Agenda
Village of Arlington Heights
Design Commission
Community Room, 3rd Floor

Arlington Heights Village Hall
33 S. Arlington Heights Road
Arlington Heights, IL 60005
October 25, 2016
6:30 PM

- A. DC#16-106 - 1116 N. Douglas Ave. - SF/Teardown
- B. DC#16-107 - 1225 N. Walnut Ave. - SF/Teardown
- C. DC#16-124 - Esplanade at Arlington Heights - 2920-3020 W. Euclid Ave. - Sign Variation

PROPOSED WESTGATE DENTAL FACILITY
2920-2964 WEST EUCLID AVE.
ARLINGTON HTS., IL 60005
(THE ESPLANADE)
NJ Project No. #15-6464
SIGN & STRIPING PLAN
Sheet No. C-4
Plot Date: 5-19-2016-CJT

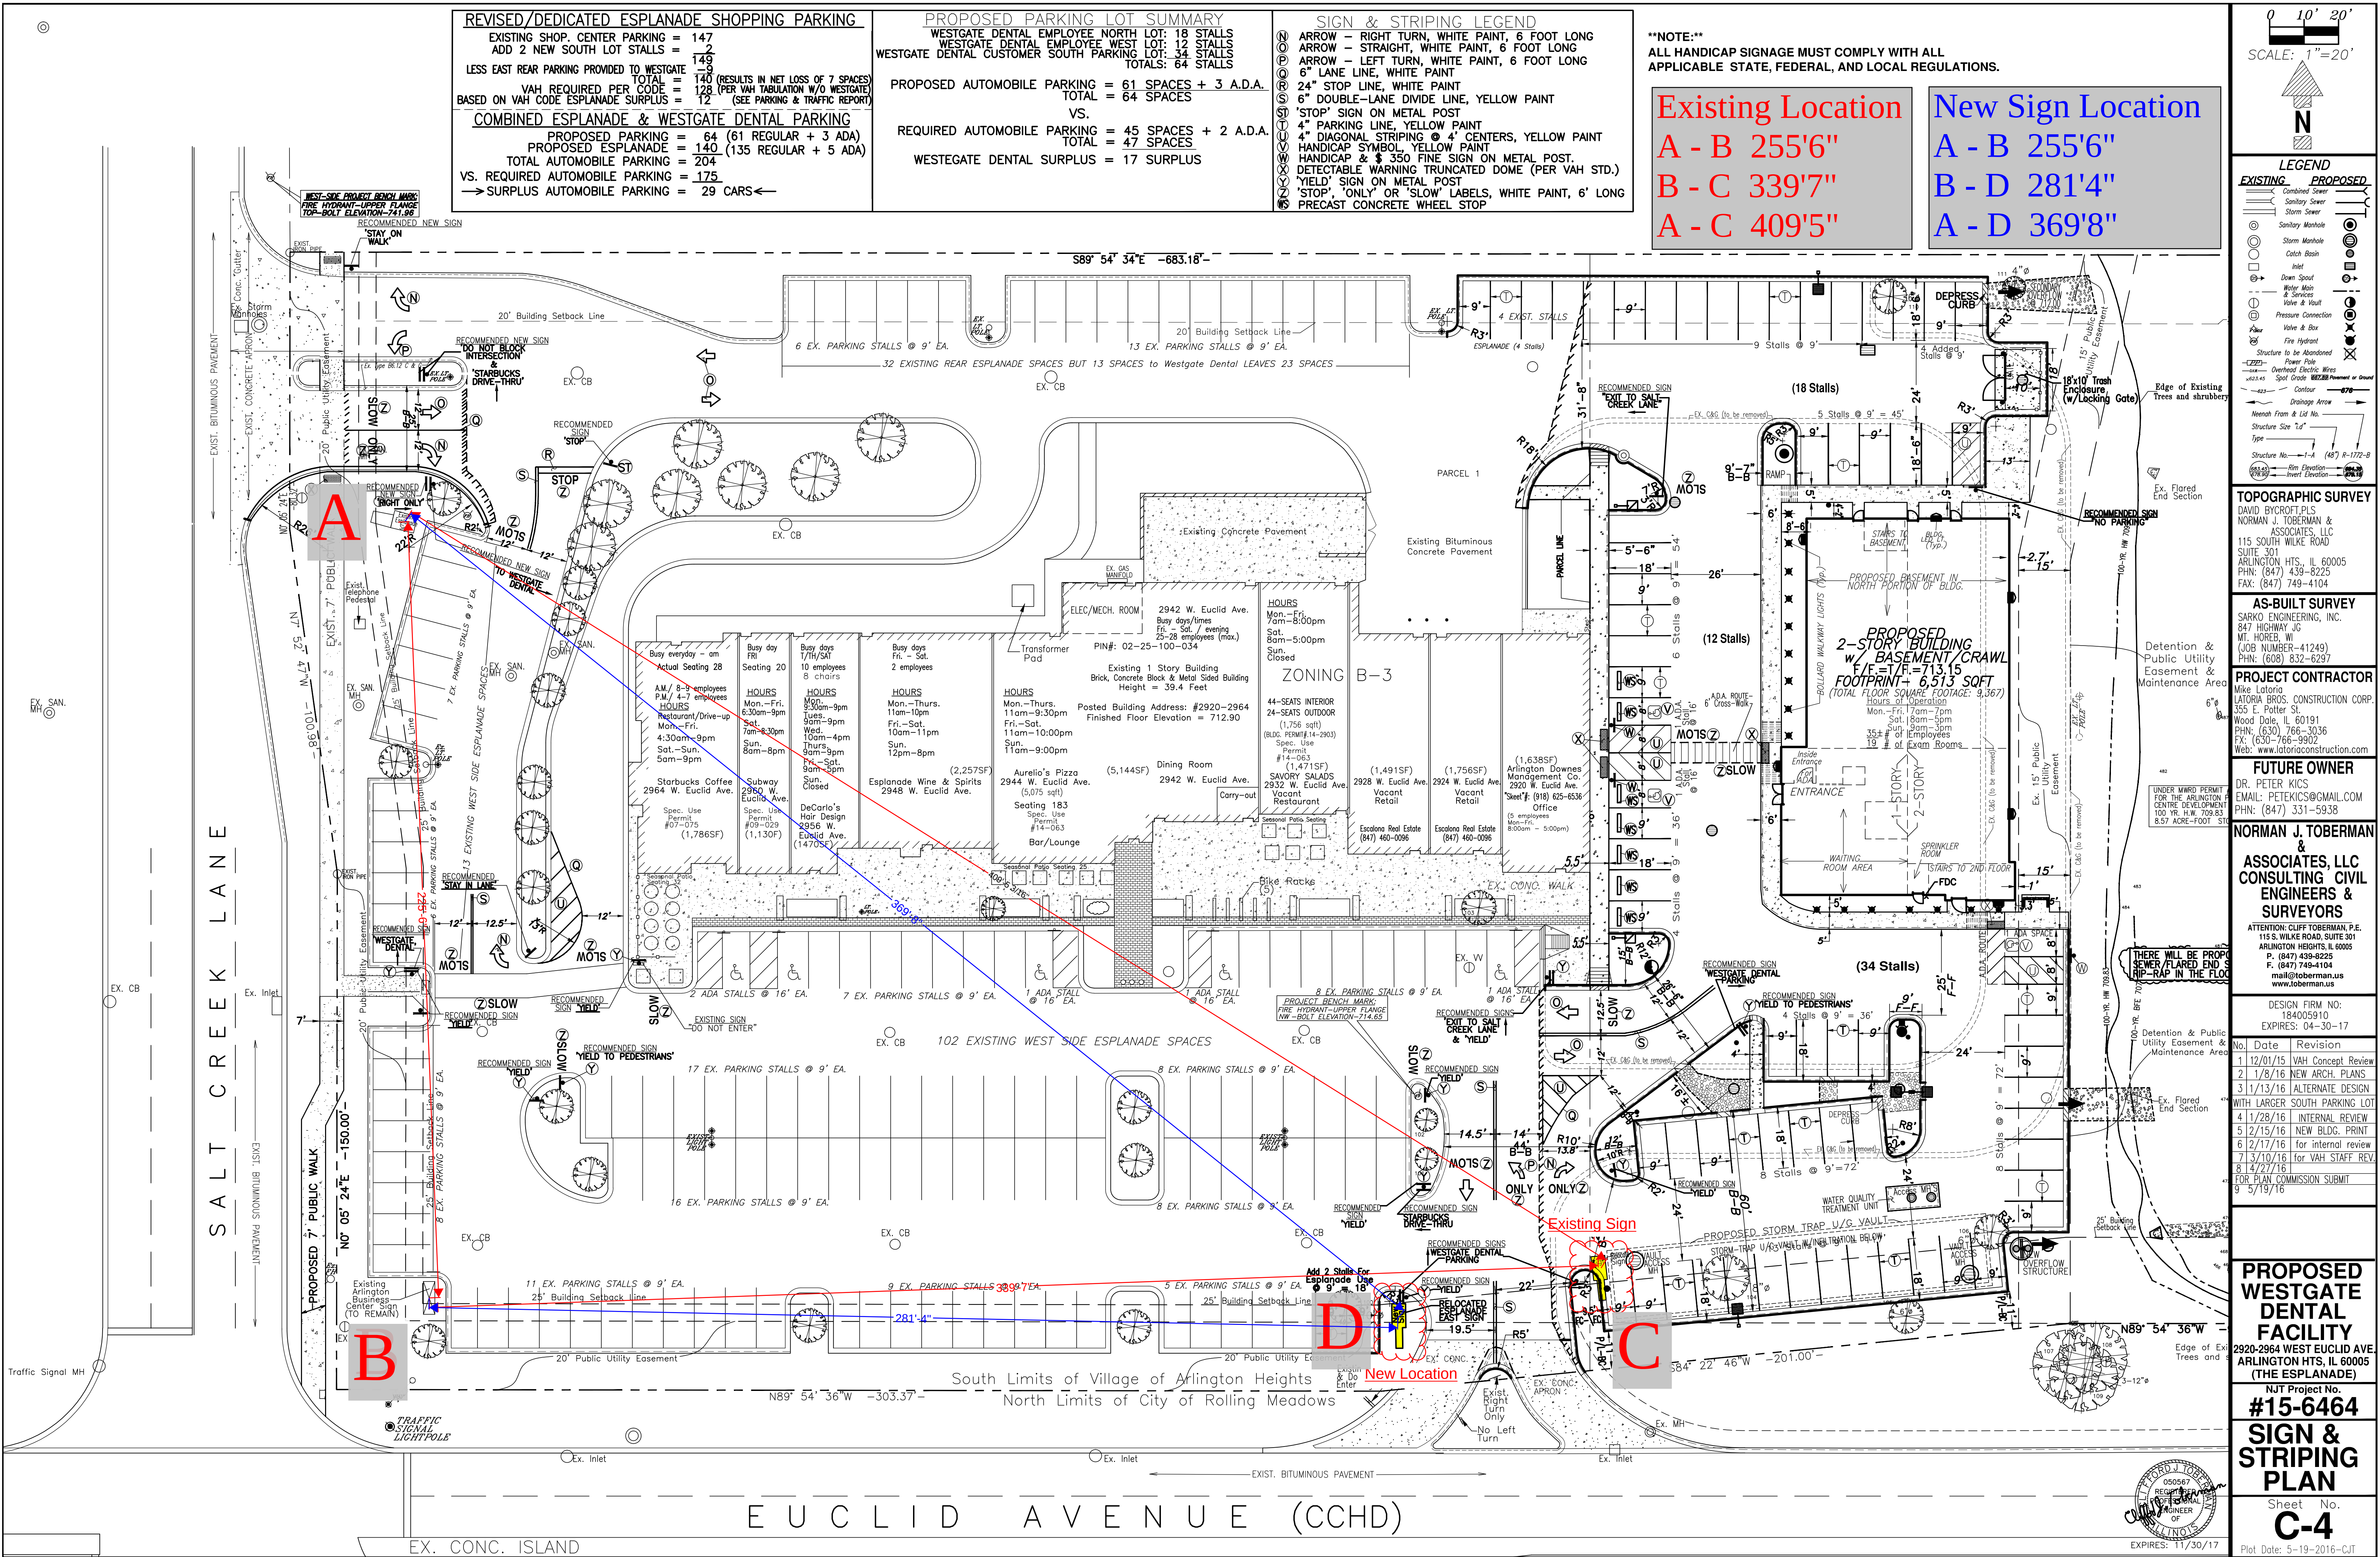
1. A variation from Chapter 30, section 30-302 Number a, to allow a 281'-4" separation between the office park sign and the multi-tenant project identification sign on Euclid Avenue where the minimum separation is 800 feet.
2. A variation from Chapter 30, section 30-302 Number a, to allow a 503'-8" separation between the multi-tenant project identification sign on Euclid Avenue and the multi-tenant project identification sign on Salt Creek Lane where the minimum separation is 800' feet.

At this time, the petitioner is requesting an amendment to the previously approved separation distances to allow relocation of the existing Euclid facing multi-tenant Esplanade ground sign from the east side of the Euclid entry drive to the west side of the entry drive. Relocation of the sign is required to accommodate development of the east end of the site with a new Westgate Dental building and corresponding parking area. The relocation of the existing sign results in a 59'-2" reduction in the required separation distance between the signs, so new sign variations are required.

It is recommended that the Design Commission **approve** the requested sign variations for the *Esplanade at Arlington Heights* at 2920-3020 W. Euclid Avenue. This recommendation is subject to compliance with the plans received on 10/07/16, Federal, State, and Village Codes, regulations, and policies, the issuance of all required permits, and resolution of the following:
